**CERTIFICATE OF APPROPRIATENESS**

**RE: Application Number 20-6760; 1980 Edison, Boston-Edison Historic District**

SITE PLAN SCALE: 1" = 12'-0"	SCALE 1" = 12'-0"	DATE
	DRAWN BY RJW	REVISED
	APPROVED	DRAWING# 1

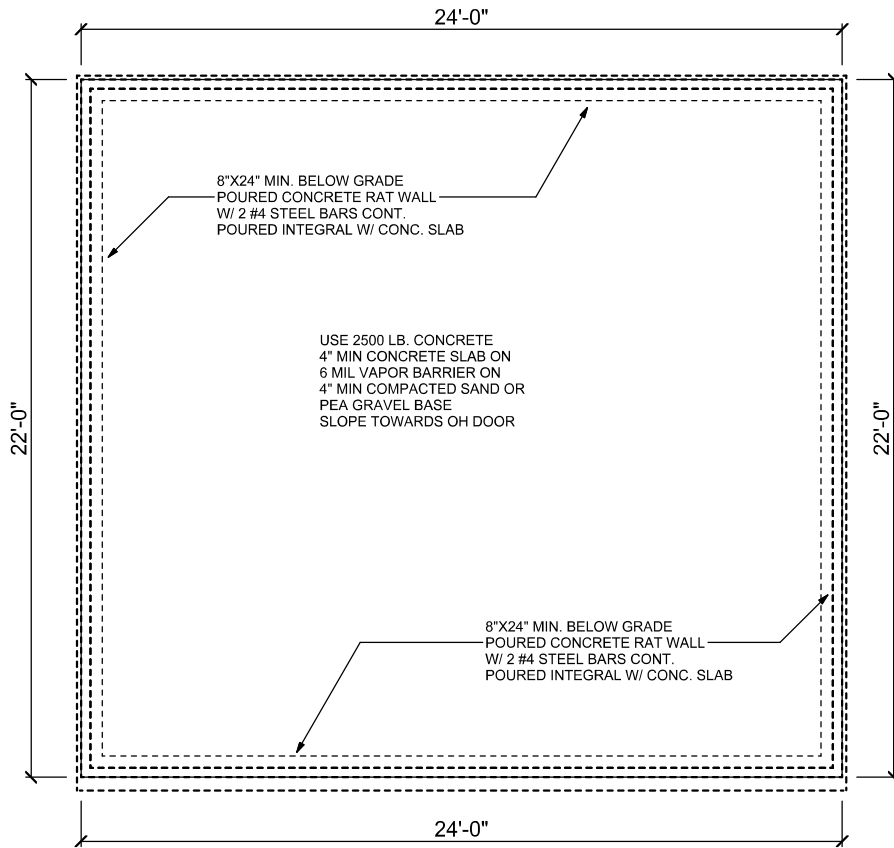
The driveway, front porches and entry door/sidelites were approved with the following conditions:

- No decorative accessory pieces, such as the super spot parking markers, will be installed within the permeable paving system.
- Should new face brick be needed for the porch, it shall match the historic brick in dimension, color, composition, pattern and profile. A historic mortar mix, matching that of the existing mortar, shall also be used. The existing stone caps, shall be reused, or new stone caps will be specified (no concrete caps).
